STAFF REPORT:	C.U.P. 21-34 Saddle Rock Subdivision - Preliminary Plat
HEARING DATE:	December 9, 2021
TO:	Planning and Zoning Commission
STAFF:	Cynda Herrick, AICP, CFM Planning and Zoning Director
APPLICANT / OWNER:	Ryan and Heidi Schneider 291 Ashton Lane McCall, ID 83638
ENGINEER:	ABCO Engineering 119 N Midland BLVD Nampa, ID 83651
SURVEYOR:	Chip Bowers, Bowers Land Surveys, Inc. PO Box 976 Cascade, ID 83611
LOCATION:	RP12N04E174094, RP12N04E175764, and RP12N04E175821 SW ¼ Section 17 and the S ½ Section 18, T.12N, R.4E, Boise Meridian, Valley County, Idaho
SIZE:	165 acres
REQUEST:	Single-Family Residential Subdivision
EXISTING LAND USE:	Agriculture (Timber Production)

Ryan and Heidi Schneider are requesting a conditional use permit and preliminary plat approval for a 32-lot single-family subdivision on approximately 165 acres.

PRELIMINARY PLAT
for
SADDLE ROCK SUBDIVISION PHASE 1 & 2
LOCATED IN THE S1/2 OF SECTION 18 &
THE SW1/4 OF SECTION 17, T. 12 N., R. 4 E., S.M.,
VALLEY COUNTY, IDAHO

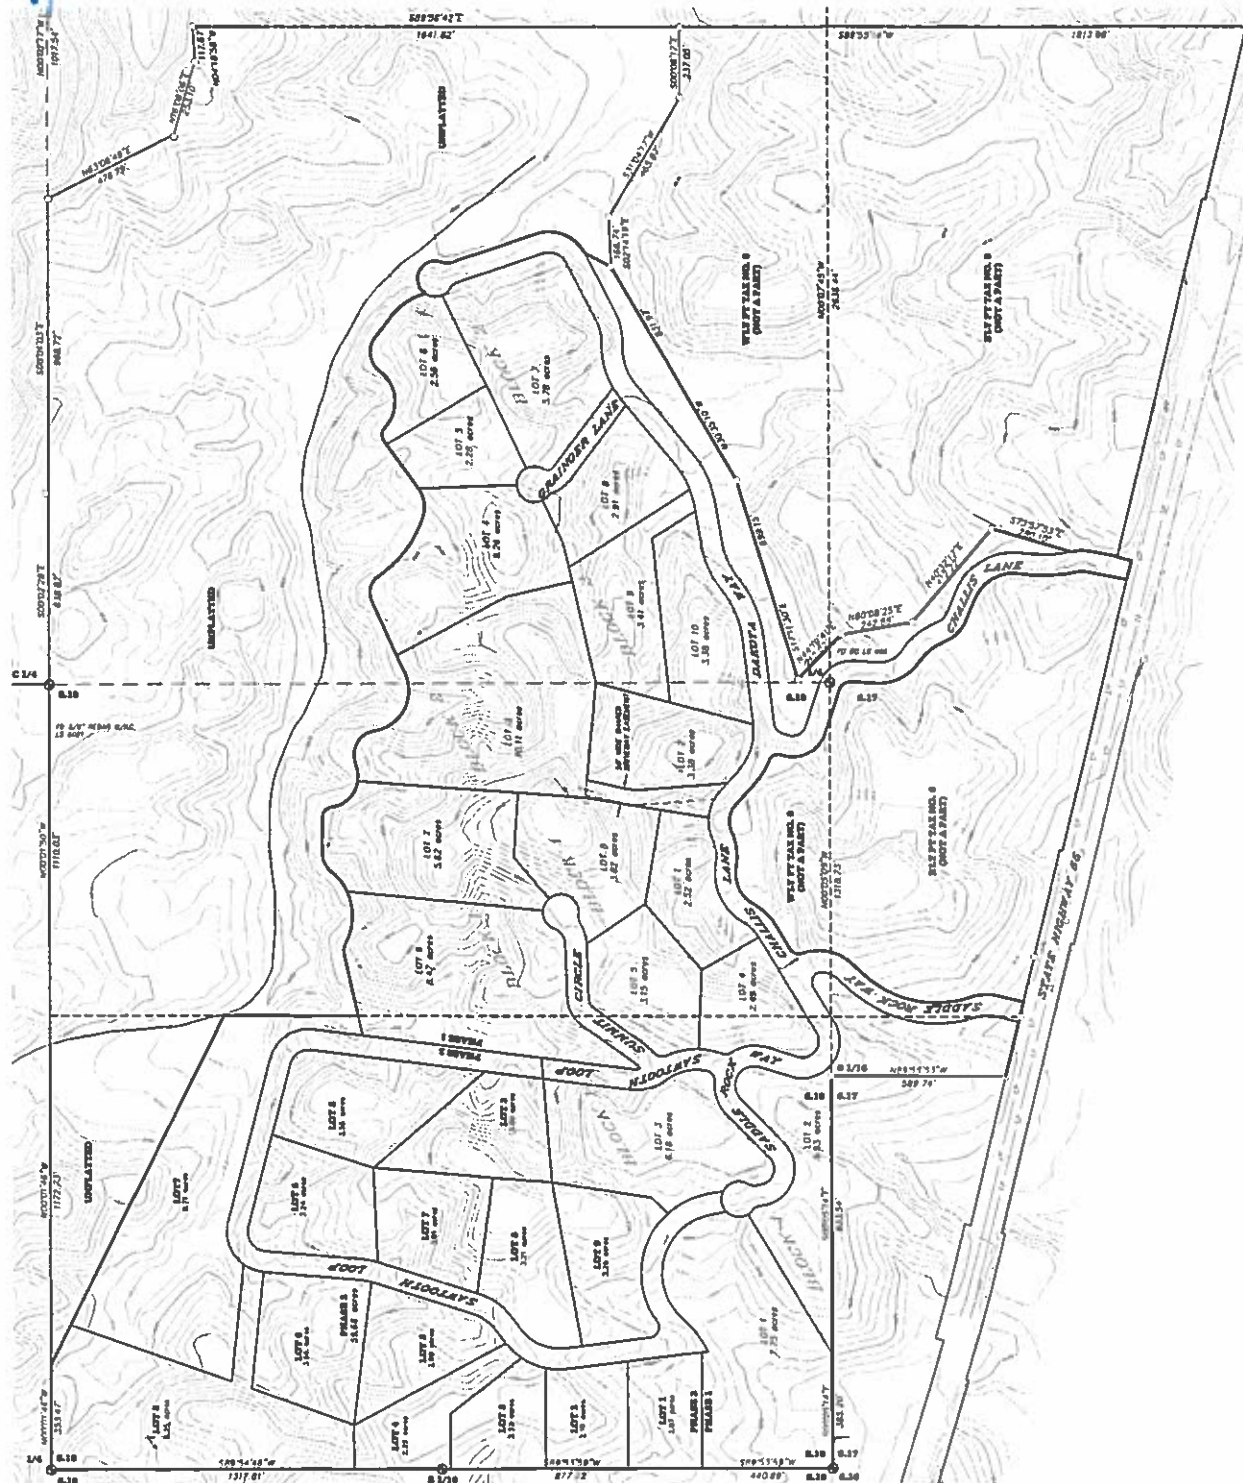
1. All lots must have 30-ft frontage on a platted road. Therefore, the shared driveways will need to be 70-ft rights-of-ways built to a private road standard or lots (Lot 3, 4, 5) could

be a flag lots with shared driveways.

4. Conduit for fiber optics is required.
5. Proposed road names need to be modified: Sawtooth Loop and Summit Circle are not acceptable. The cul-de-sac currently named Summit Circle should have a suffix of Court.

8. General Note 2 should be herein vs herin.
9. General Note 3 should be changed to Saddle Rock Subdivision.
10. Will you allow short-term rentals? If not, place in your CCR's (4.01). Short-term rentals are considered residential uses not commercial uses.

A revised preliminary plat was submitted on November 29, 2021. This revision addresses the lack of frontage issue.
